# WRITTEN COMMUNICATIONS

## Considerations for rezoning parcel id# 0178-09-0023 also known as Gulf Harbor Estates to RSF 2 Venice Code FRONTAGE FRONTAGE 80 FOOT MINIMUM LOT WIDTH

### Research provided to support the RSF 2 Venice City Code requirements for the proposed Gulf Harbor Estates

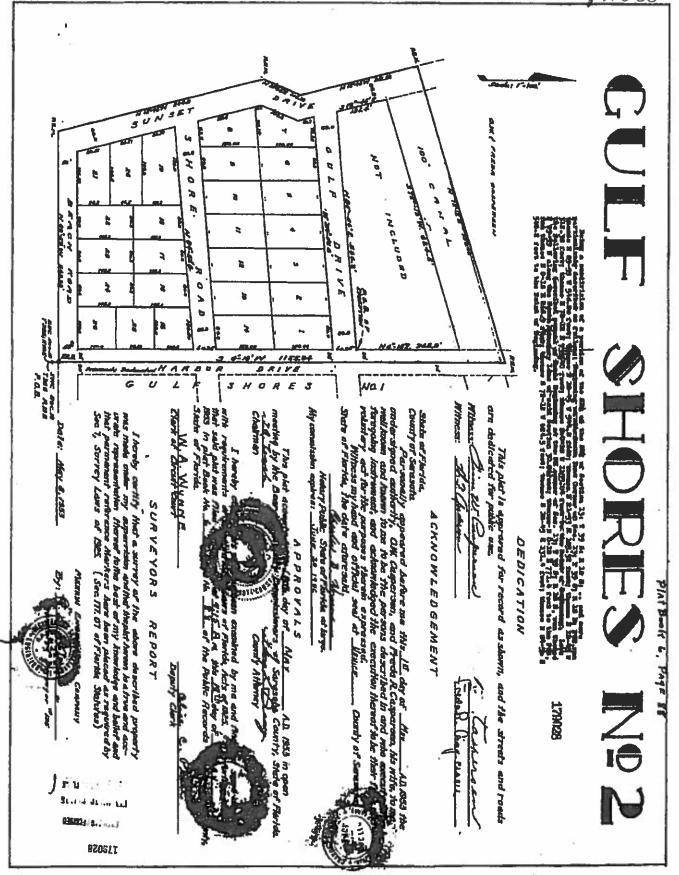
I am very concerned about this proposed project devaluing my home and others in my neighborhood by reducing the size of the lots and the frontages to accommodate their plan. Gulf Harbor Estates Petition Number: 16-4PP

PROPERTIES SOUTH OF PROPOSED

COMBINED TOTAL OF 211 FOR BOTH

## PROPERTIES NORTH OF PROPOSED
